Village of Lincolnwood Plan Commission

SUBJECT: Plan Commission Workshop – Review of South Bay Partners Senior
Development Submittal

**Village of Lincolnwood
Development Review Team
Summary Review**

**Proposed Senior Development
South Bay Partners**

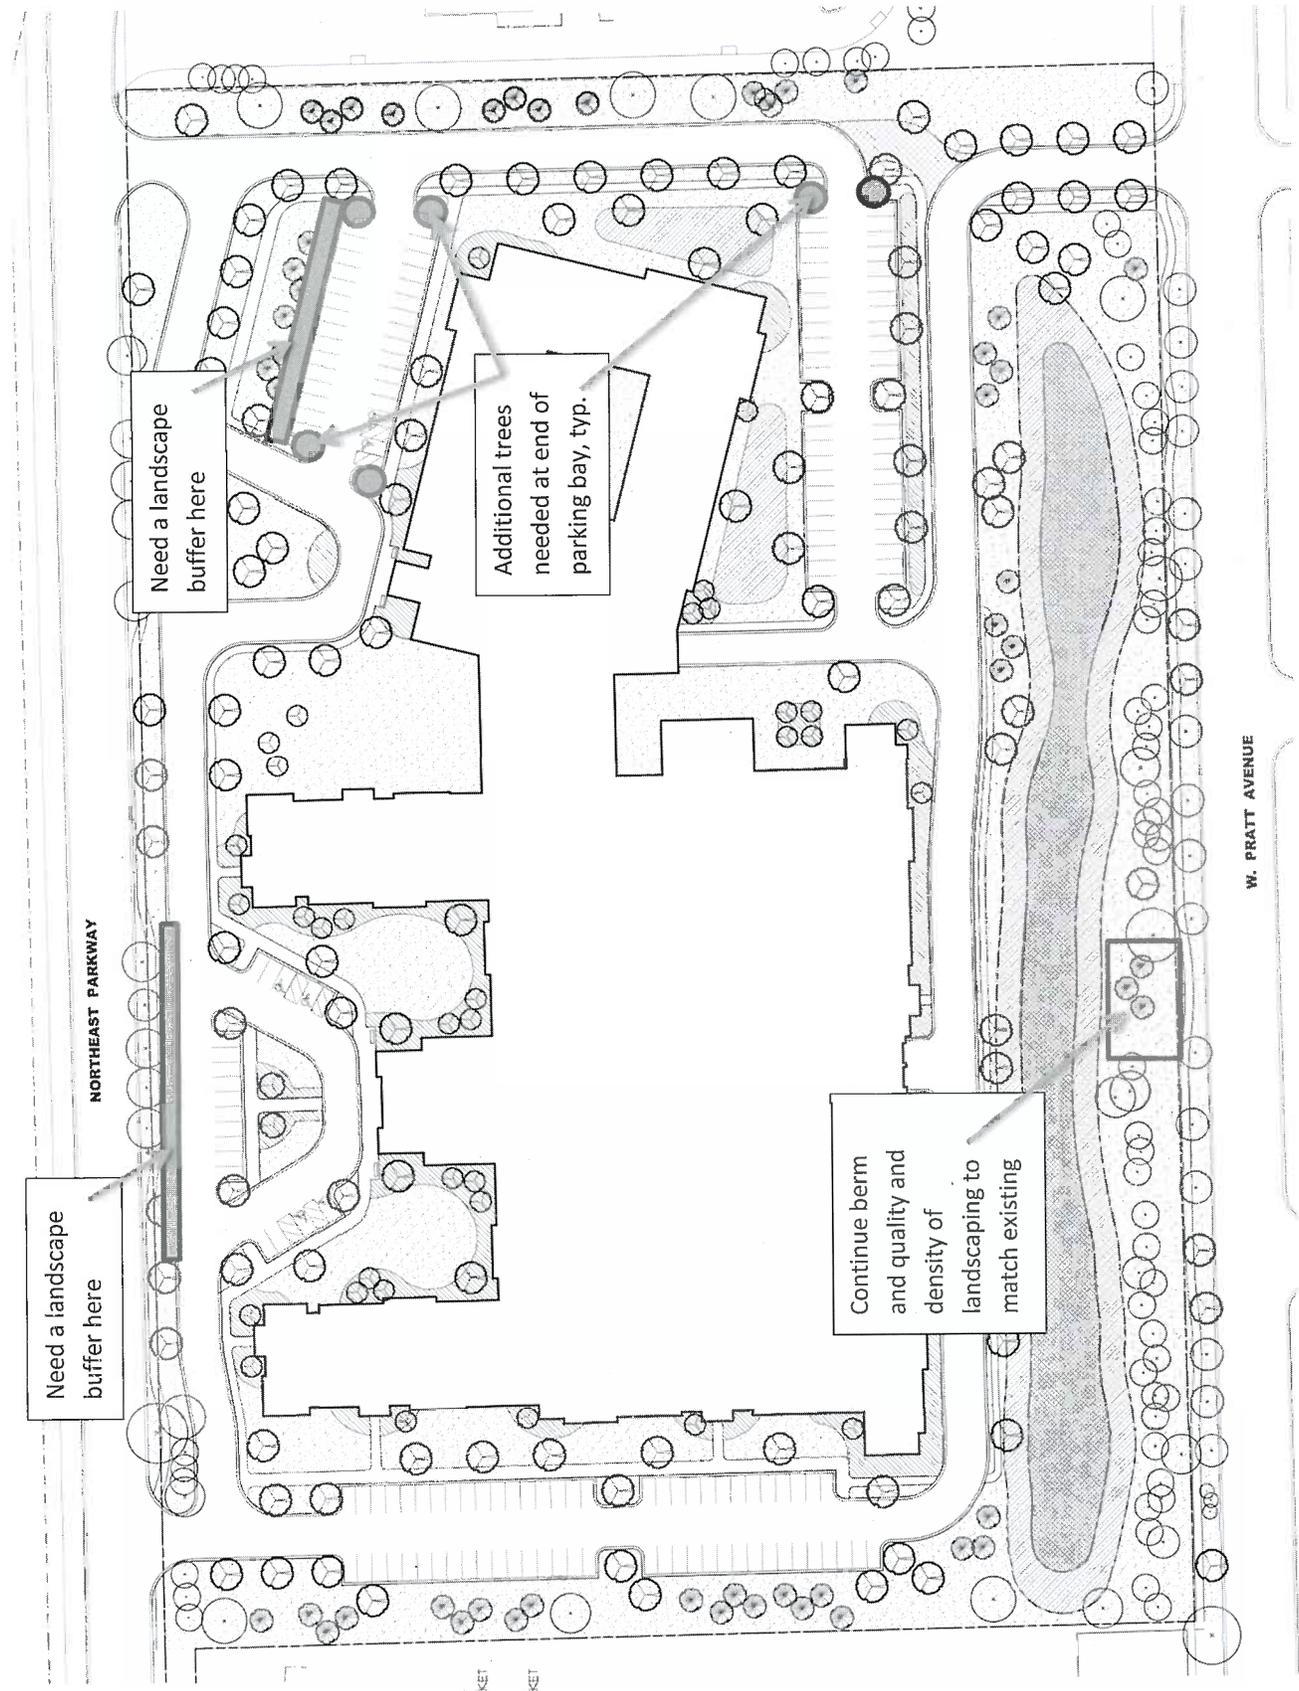
- The two parking lots on the north side of the development will need landscape buffers along the street side. See attached Illustration.
- All planting beds at the ends of the parking bay rows need to have trees as indicated section 6.14, item (2) b. See attached Illustration.

Need a landscape buffer here

Need a landscape buffer here

Additional trees needed at end of parking bay, typ.

Continue berm and quality and density of landscaping to match existing

**CONCEPT SITE PLAN
SENIOR HOUSING DEVELOPMENT
LINCOLNWOOD, ILLINOIS**

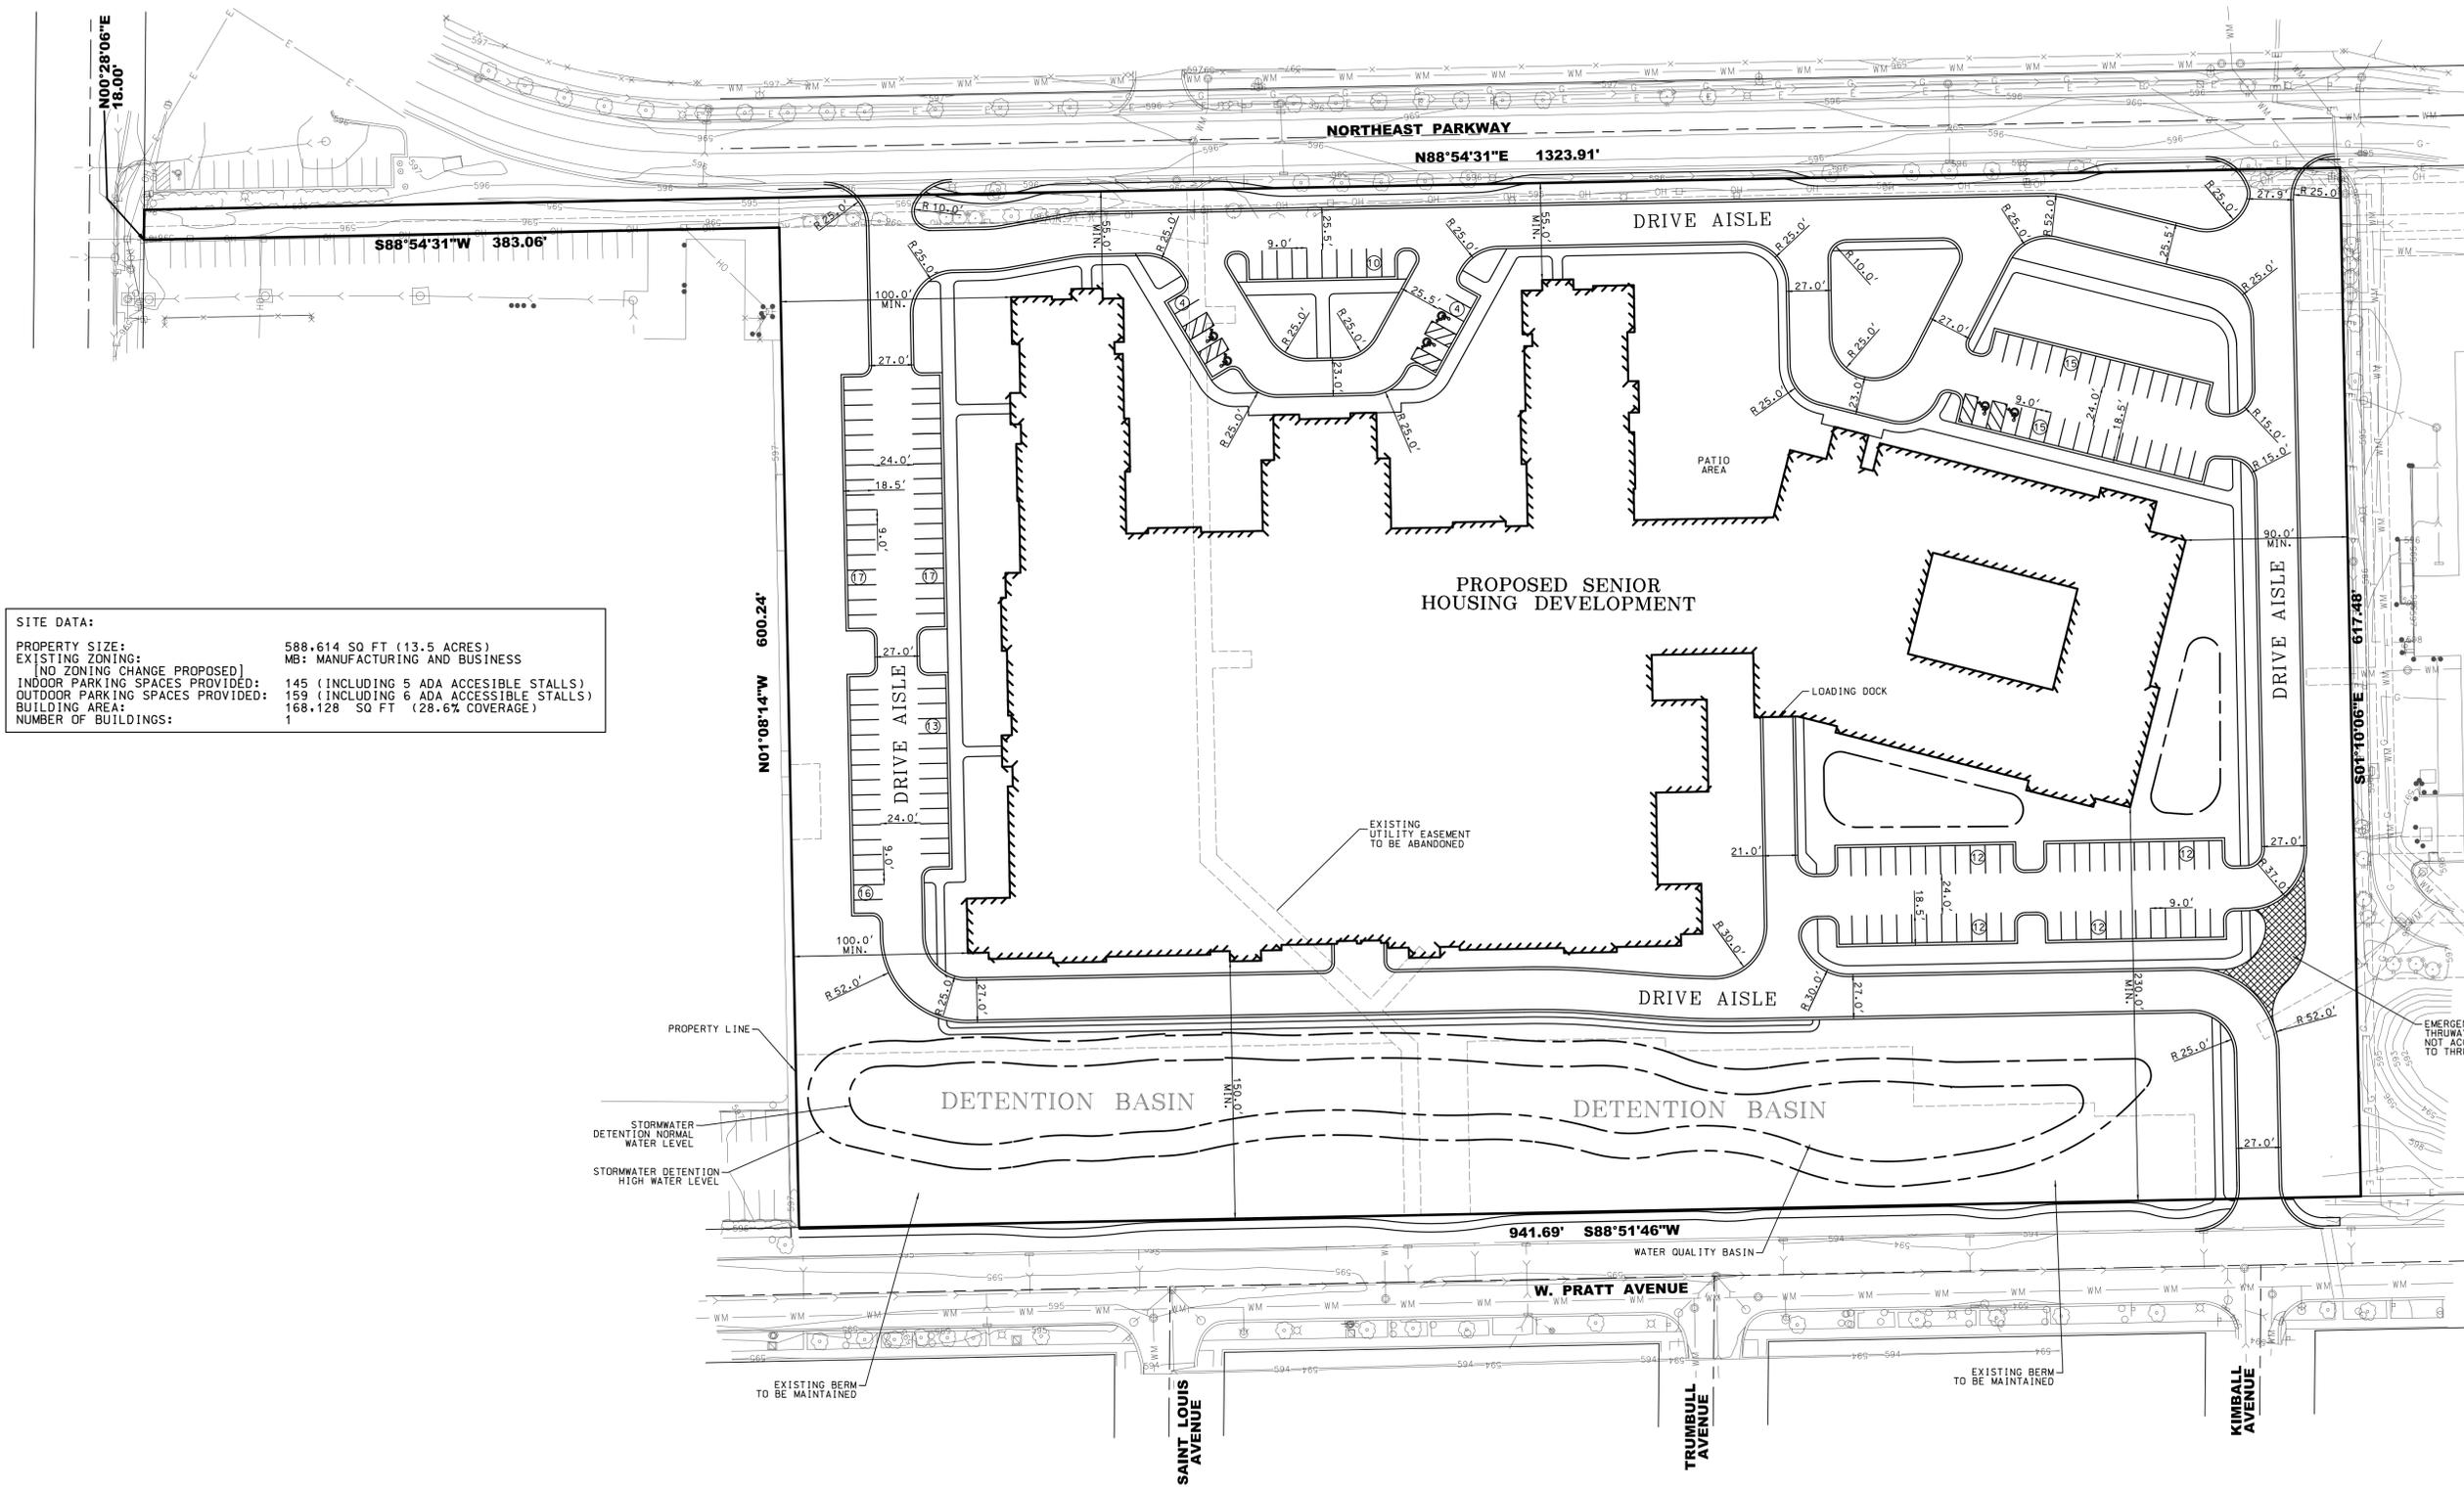
- Add benches/trash receptacles on site plan at various property locations. Consider planters nears entranceways for seasonal flowers
- Consider a designated walking route on property for residents, consider extending sidewalk west in panhandle to Central Park, and extend sidewalk eastward on north side of detention area

- Add Stop Sign and Stop Bar notations to plans at all driveway exits
- Add thermoplastic pedestrian crosswalks to plans at driveway crossings and as appropriate throughout development

- Identify on site plan location(s) for site signage
- Identify refuse holding area(s) on the property (none indicted)
- Describe the Green Roof amenity and provide details concerning the proposed patio area

- Add trees to all parking bay row end caps
- Add dimensions to site plan as indicated by departments and confirm public sidewalks are 5 feet in width
- Review sight line and existing trees at west entrance from Northeast Parkway

- Add stop sign and stop bar notations at all exits on plans.
- Identify number, type and typical route for service delivery trucks for development.

- No exterior refuse holding areas are indicated. Will there be any? If so they will need to be screened with landscaping.
- At the west entrance along Northeast Parkway three spruce trees are indicated to be saved which is commendable but I am concerned about traffic visibility at the intersection of the entrance and the east – west internal roadway.

- On the site plan a detention basin is shown on the south side of the development. Where is its overland flow route and how is that handled in the landscaping? How will the shoreline (emergent zone) be treated? How are the areas around the inlets and outlets treated?

**SCHEMATIC
LANDSCAPE
PLAN**

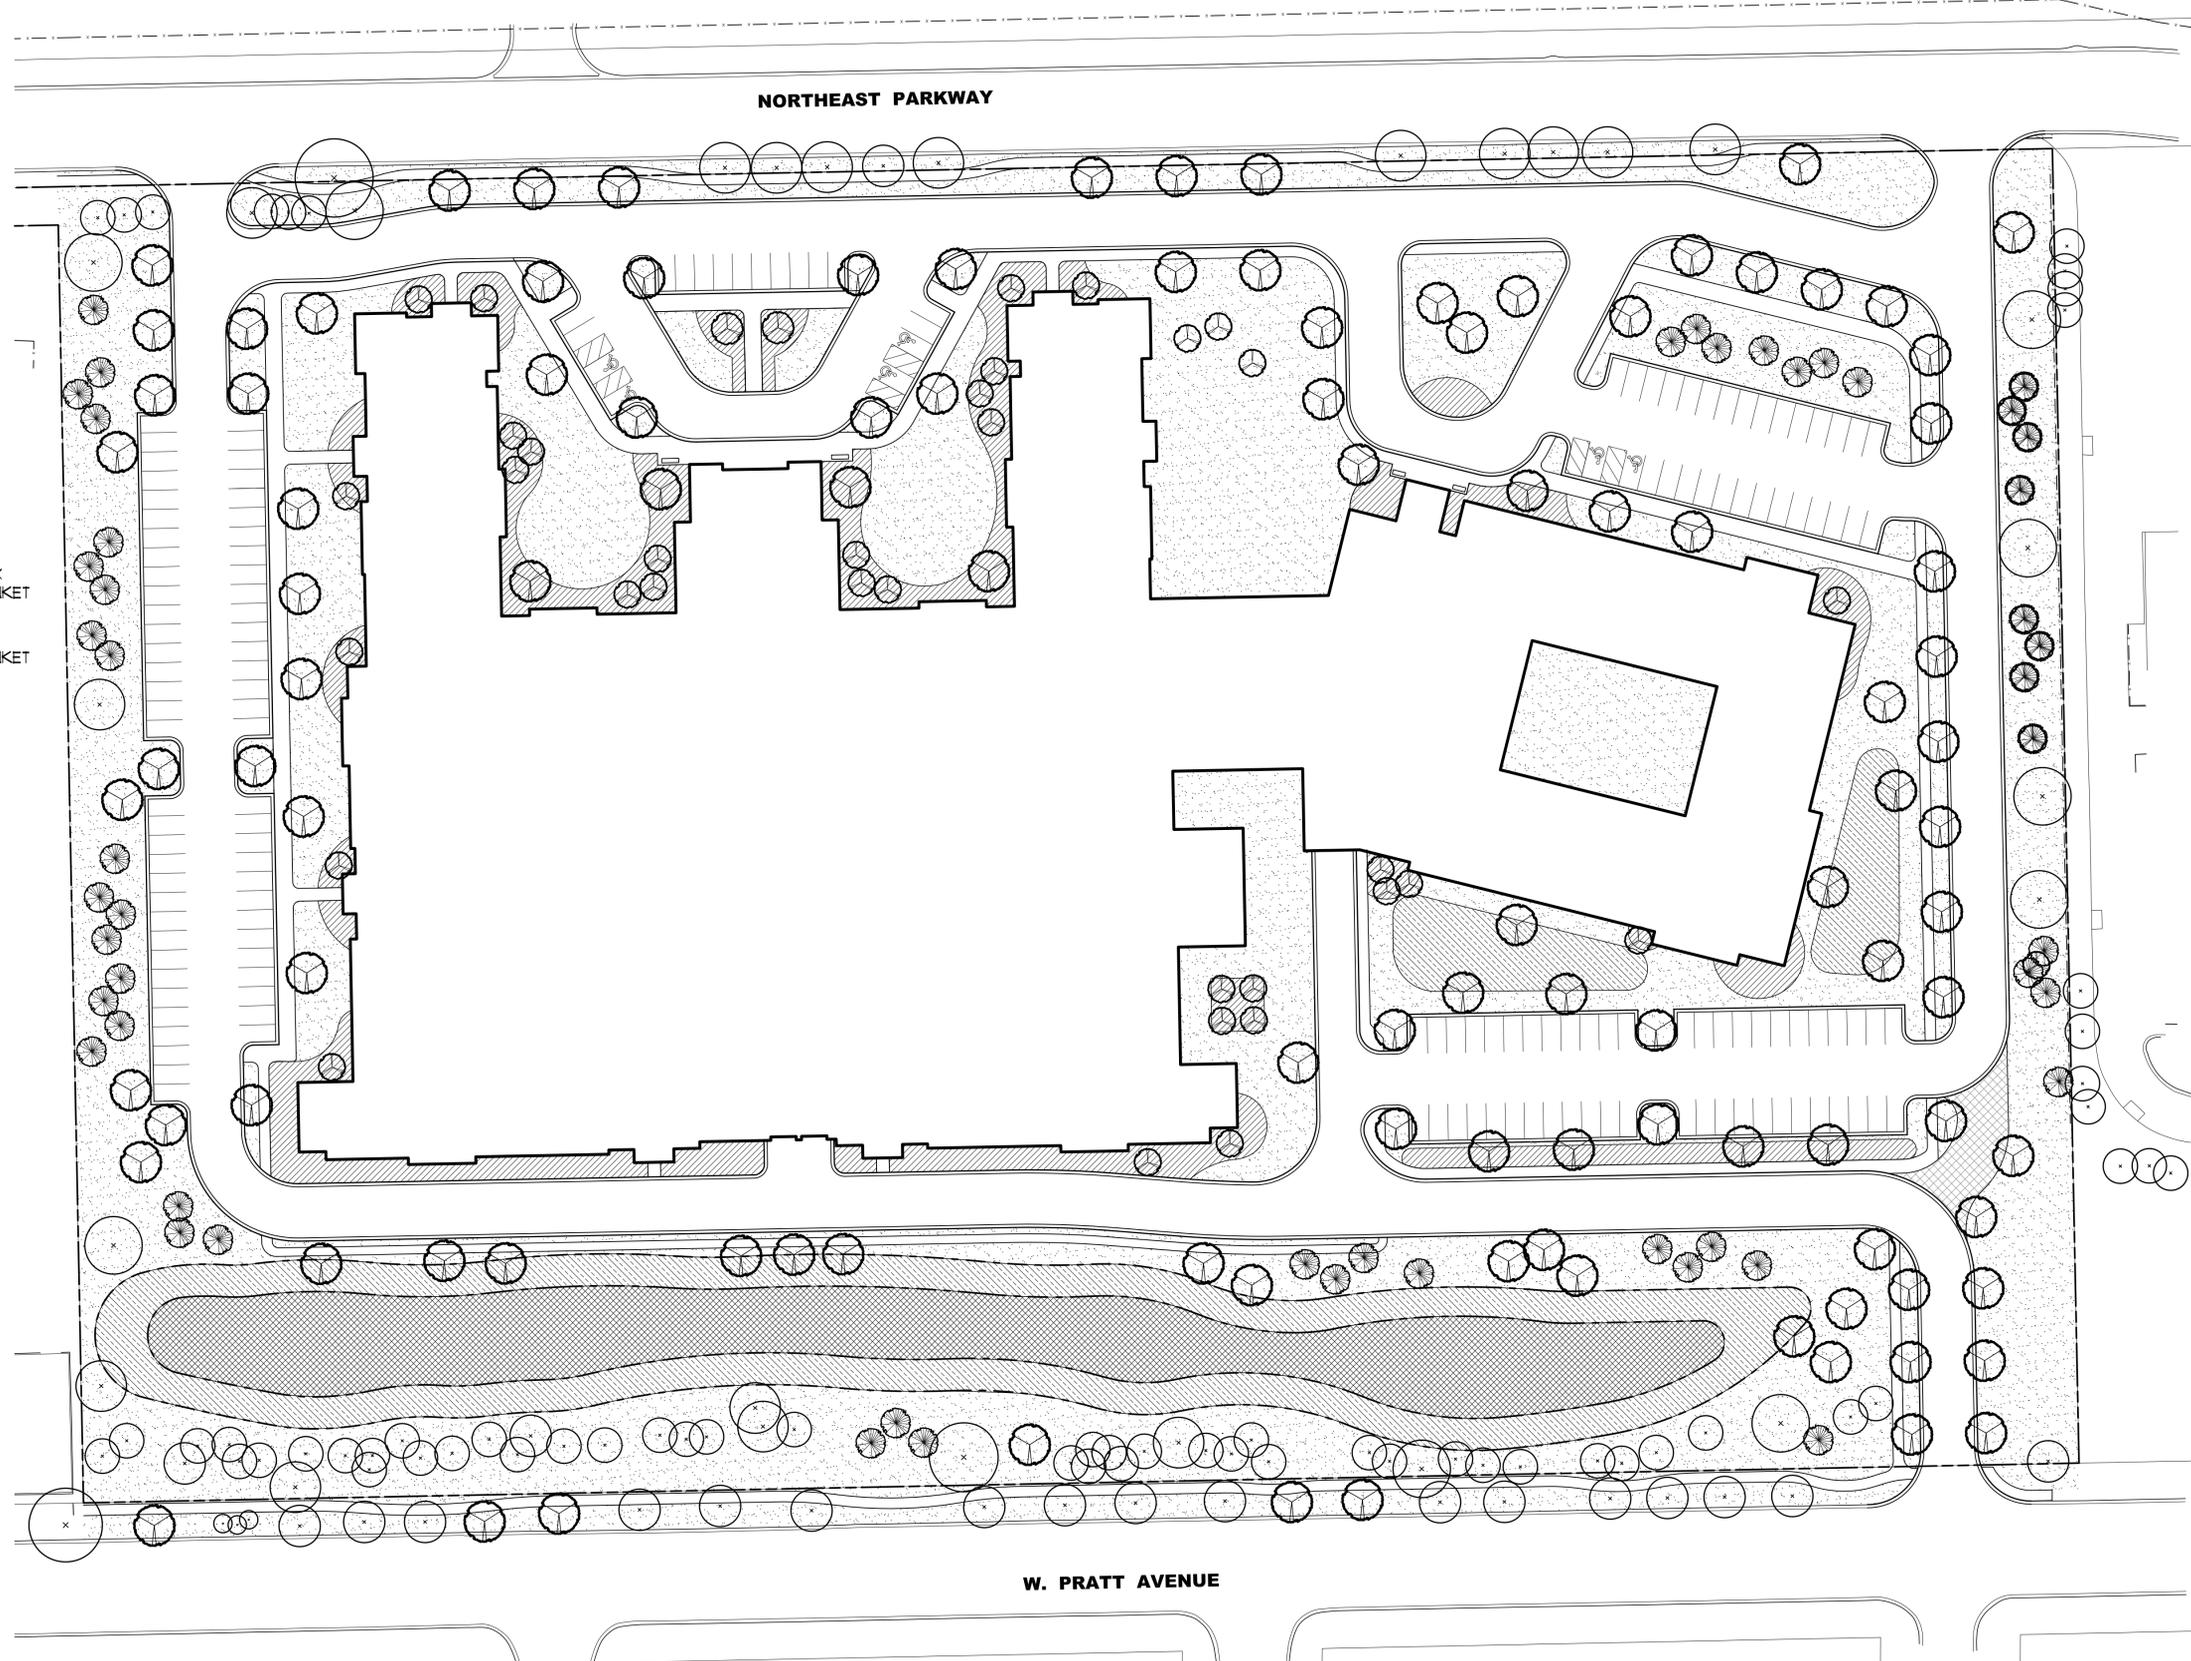
- For the 2 parking lots on the north side, add landscape buffers along street side and extend Pratt Avenue berm in area where drive lane is being removed

- Provide landscape details for detention area
- Identify proposed size and location of water and sewer connections. Connections must be approved by Public Works

- Will there be any downspouts on the building and if so how will they be handled in the landscape?
- The previous development provided a berm and extensive landscaping along West Pratt Avenue and we can see that it is the intent of the developer to save and maintain it, however we suggest that this berm and quality of landscape be continued in the area of the former south entrance.
